SPECIFICATIONS FOR STATE ROAD SANITARY SEWER IMPROVEMENTS

ADDENDUM NO. 1

March 7, 2011

TYPICAL BORING DETAIL

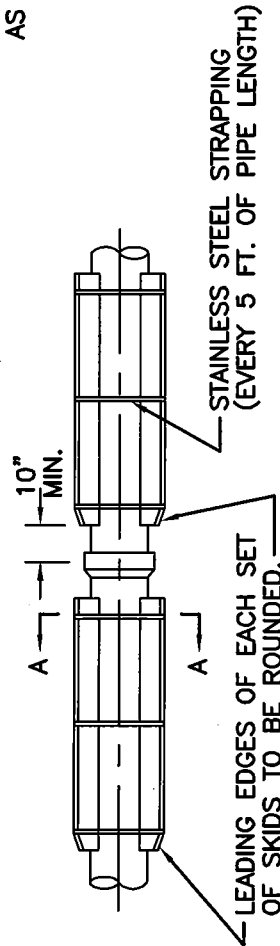
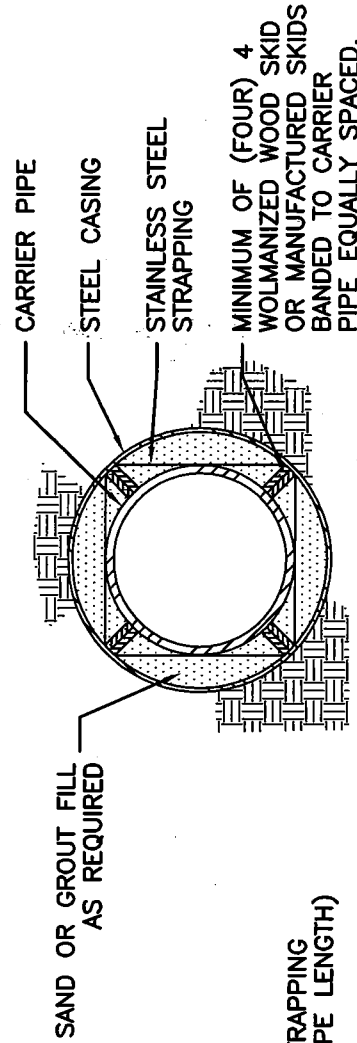
3. SHEET 5

REPLACE The typical boring detail with the attached revised typical boring detail.
